**Frequency Operating Standards for Tasmania
Interim Frequency Standard Determination Supplementary Submission**

This letter is submitted by Aurora Energy (Tamar Valley) Pty Ltd (AETV) the new owner of the Tamar Valley Power Station under construction at Bell Bay in northern Tasmania. AETV is a subsidiary company of Aurora Energy Pty Ltd and apart from ownership all other arrangements are unchanged. The new owners are in full support of previous submissions provided by Alinta Energy into this review process. We would like to make the following comments in support of the interim determination by the Reliability Panel's draft report on Frequency Operating Standards (FOS) in Tasmania.

Figure 1 Co-optimised CCGT dispatch duration curve

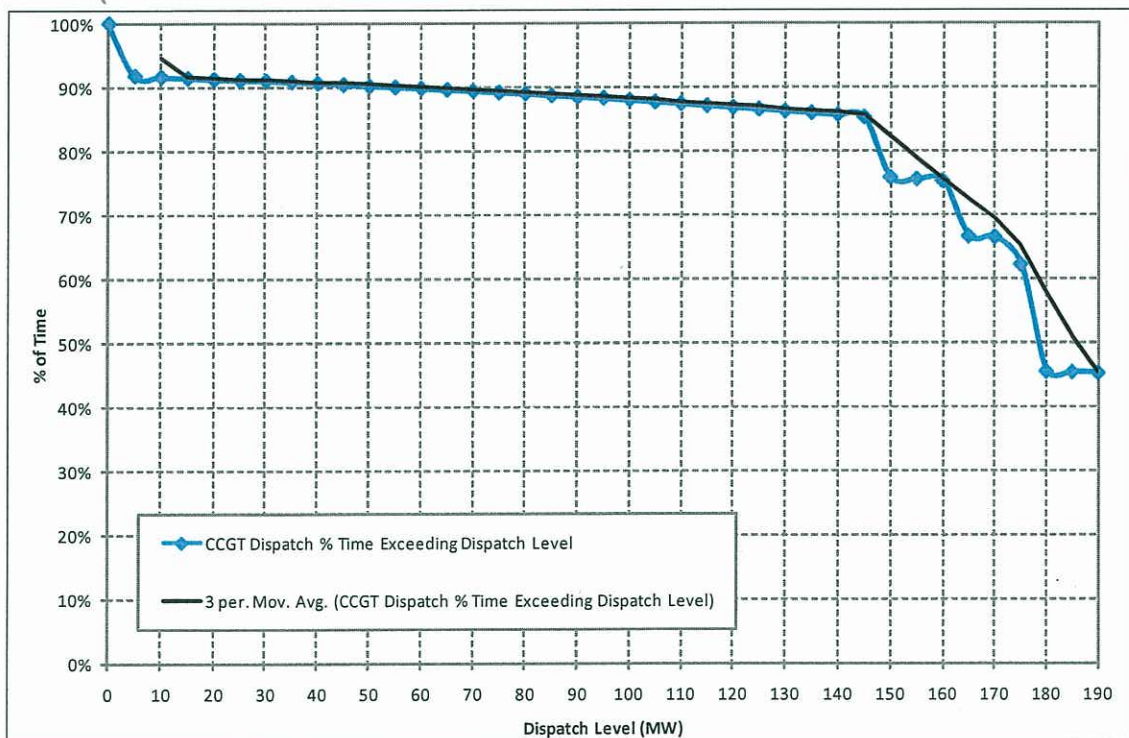
The basis of 144 MW (other than that it is the existing contingency limit) is not documented nor supported by any analysis by the panel or its consultants. AETV's own market simulations presented as a supporting secondary submission in the course of these deliberations to the panel has clearly shown that 160 MW is not a problem in Tasmania and for a significant period it is feasible to dispatch even higher.
